DATE: August 15, 2023

RE: CEQA 15164 Determination for Proposed Post-Fire and Odor Management Engineering Design/Project Description Changes (PD Change No. 5): Finding that Section 15164 of the State CEQA Guidelines applies to minor changes to the ReSource Center at the Tajiguas Landfill. CEQA Guidelines Section 15164 allows an Addendum to be prepared when only minor technical changes or changes that do not create new significant impacts would result. The Final Subsequent EIR (SEIR)(12EIR-00000-00002, SCH #2012041068) and the SEIR Revision Letter and Errata dated May 27, 2016 and SEIR Addendum dated August 11, 2017 (revised October 26, 2017), 15162 determinations dated January 15, 2020, May 18, 2020, and August 2, 2021 are hereby amended by this Addendum.

Location: The project is located at the Tajiguas Landfill on Assessor's Parcel Numbers (APN) 081-150-042, 081-150-019 and 081-150-026, located approximately 26 miles west of the City of Santa Barbara, along the Gaviota coast, Third Supervisorial District.

Exhibit 7
CMU Dust Control Misting System

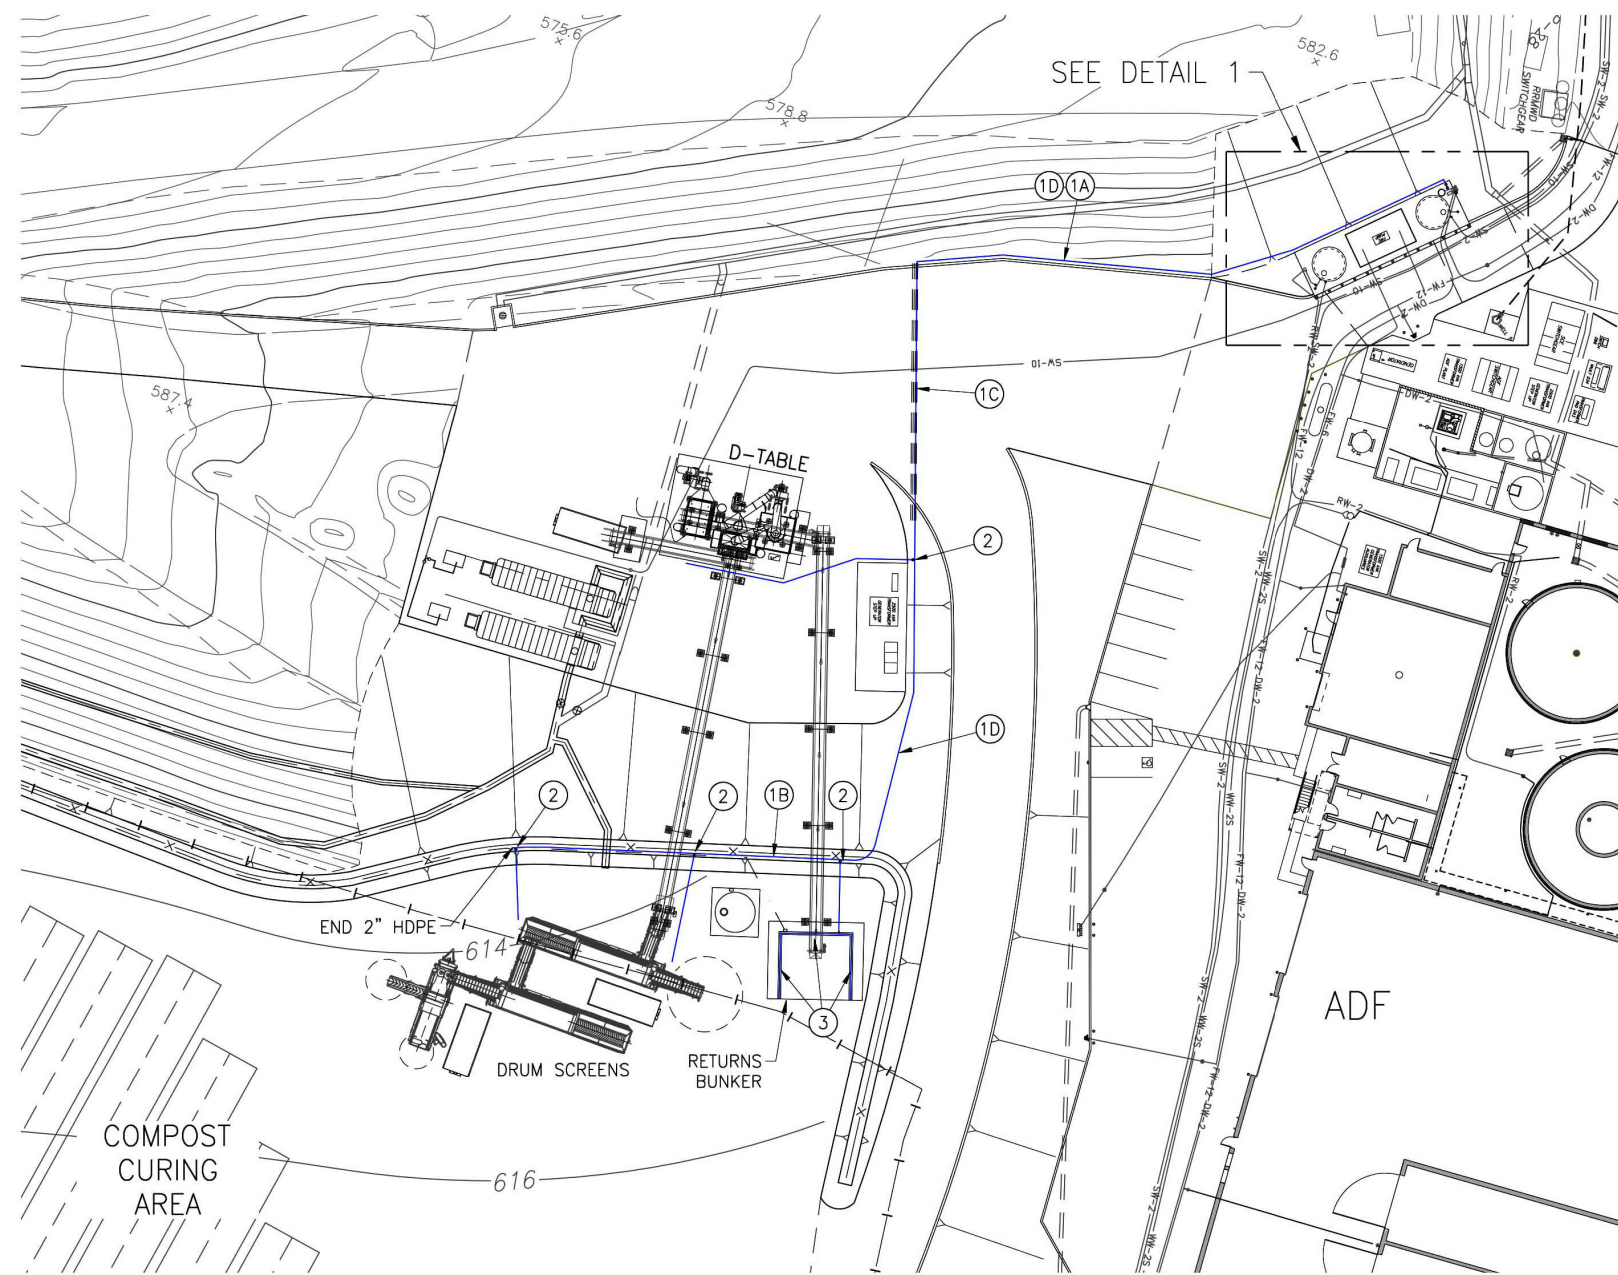
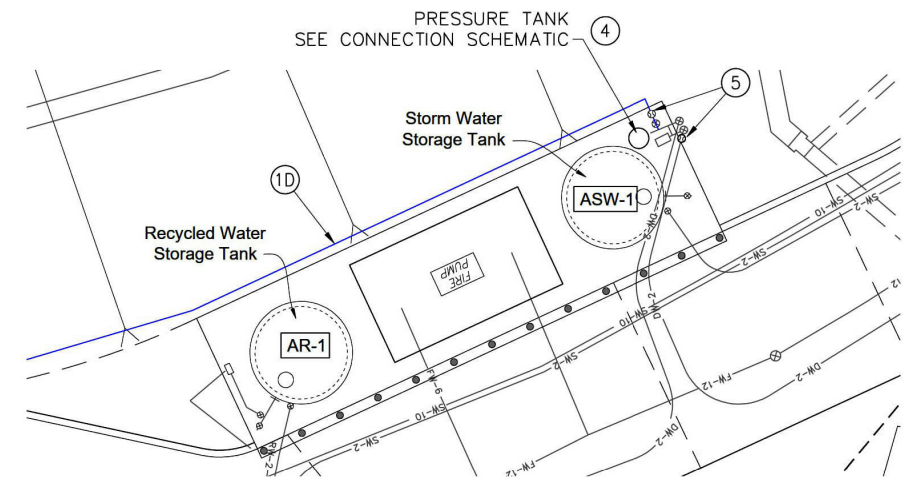
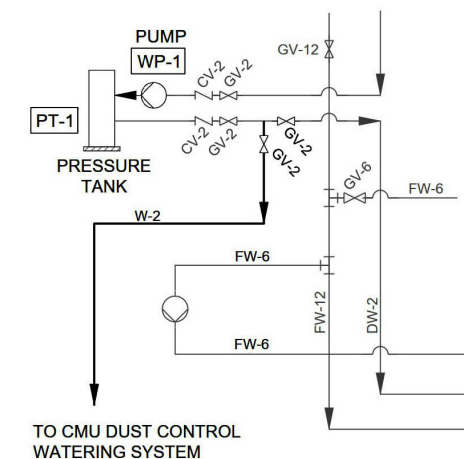
In addition to the new compost irrigation system, a new dust control misting system is proposed to control dust generated during use of the permitted densimetric table at the finished compost bunker. This system will include a new electric water pump and 528 gallon pressure tank to be located near the existing stormwater storage tank (see Exhibit 7).

Powered Screen within the ADF Delivery Hall

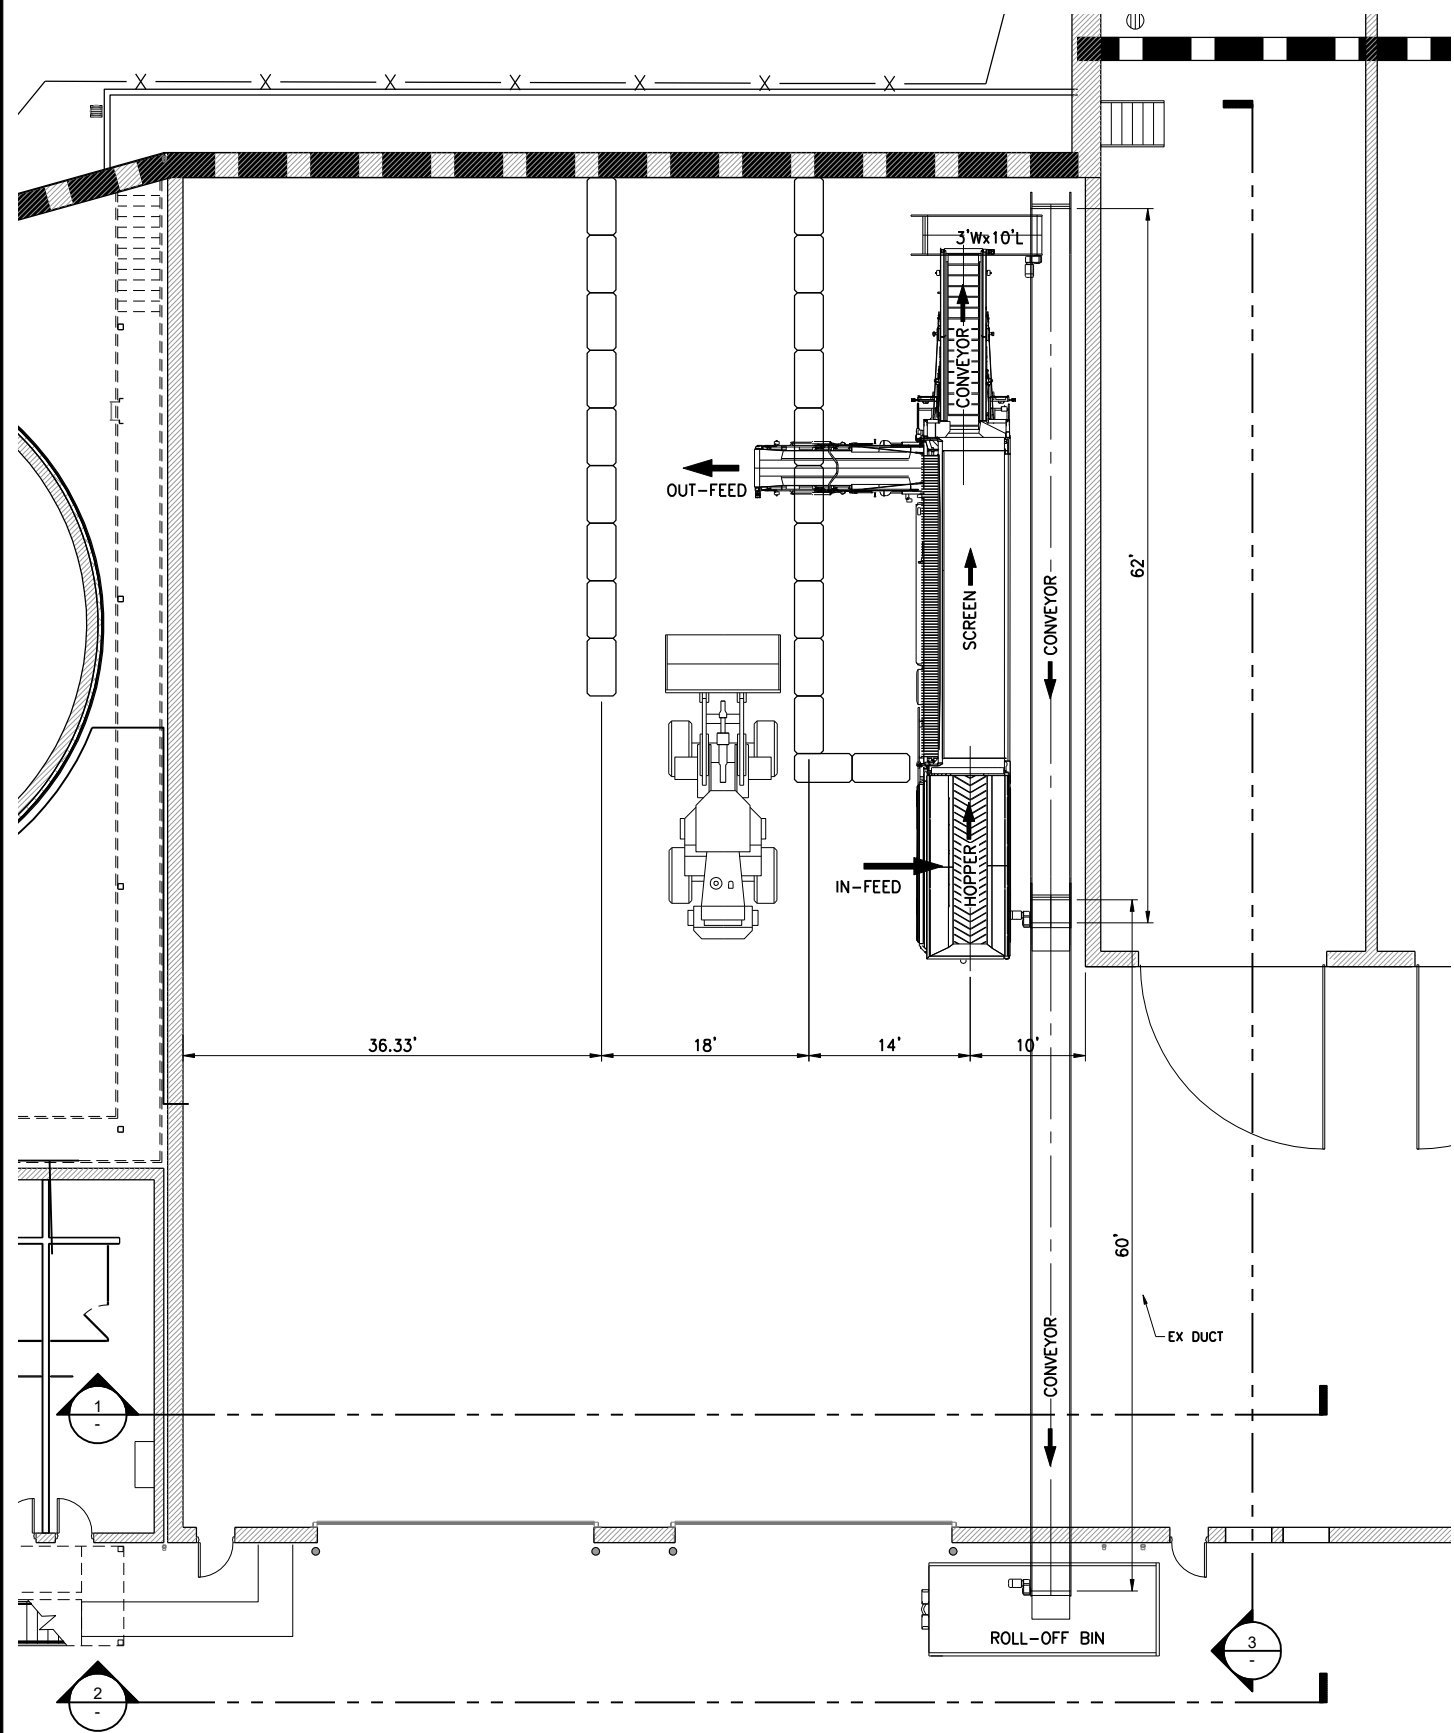
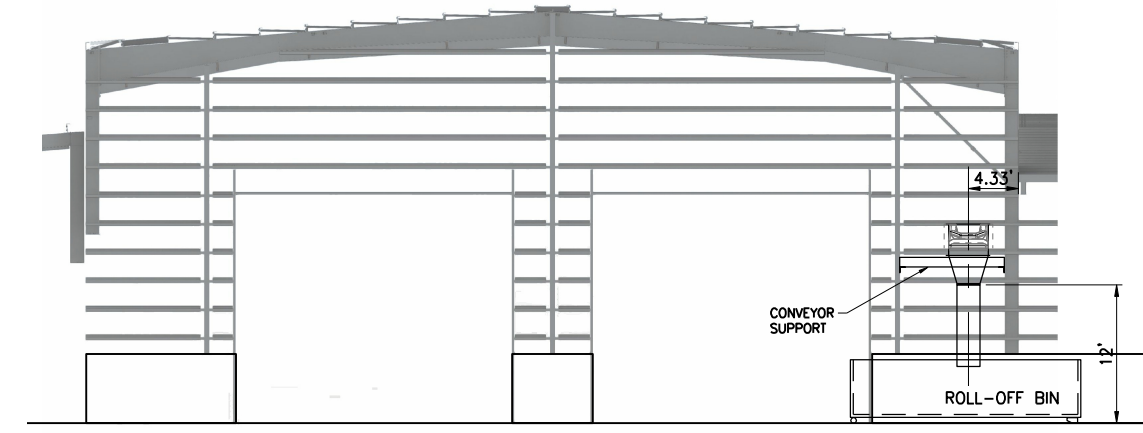
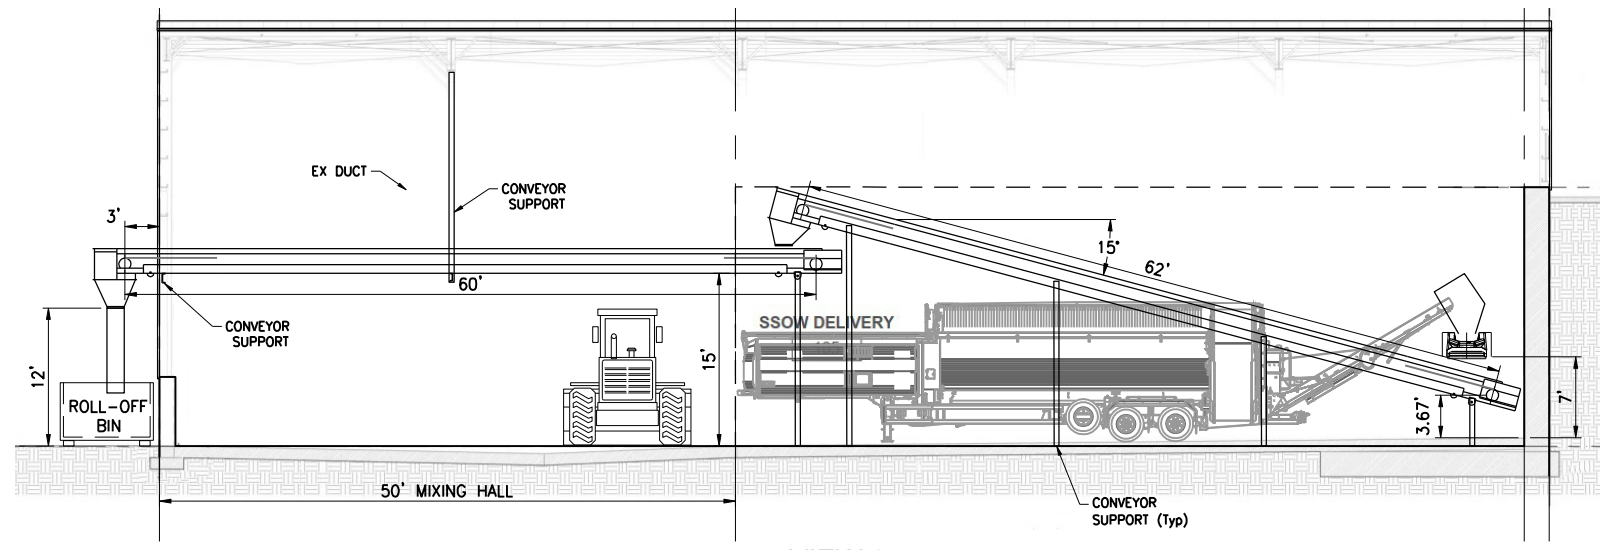
New Diesel-Powered CMU Organics Screen¹ and Increase in Composting Screening Hours (7 AM to 5 PM). The ADF went into operation on September 27, 2021. As operations were optimized, it became apparent that additional screening was required to remove plastics from the organic residue produced by the MRF. Additional screening will enable the ADF to process a much greater proportion of the organic residue. It will also increase methane production at the ADF, reduce compost volume at the CMU, and ultimately reduce the volume of residue sent to the Landfill. To achieve additional screening at the ADF, one of the two previously approved Doppstadt electric-powered screens from the CMU has been relocated to the ADF delivery hall to process the incoming organic fraction of mixed solid waste (provided by the MRF) to remove large plastic (greater than 3-inches) prior to the screened organics being loaded into the ADF digesters (see Exhibit 8).

Photo-simulation of the View from U.S. Highway 101

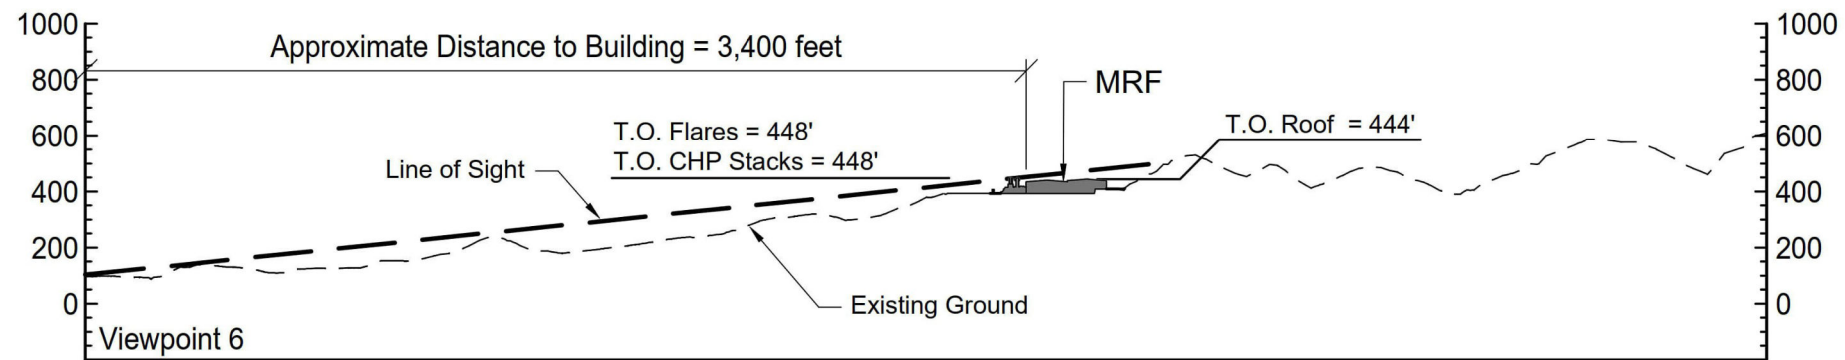
As shown in Exhibit 10, one of the two proposed vent stacks (MRF Recycling Area stack) would be visible from View 6, but would be a very small modification of the existing view of the MRF. No other facilities associated with PD Change No. 5 would be visible. The proposed Gore membrane covers over the compost piles at the CMU would be a green-brown color and not be visible from the U.S. Highway 101. Facilities proposed under PD Change No. 5 would not substantially change the visual impact as compared to the Revised TRRP addressed in the SEIR Addendum. Impact TRRP VIS-2 would remain significant but mitigable (Class II).
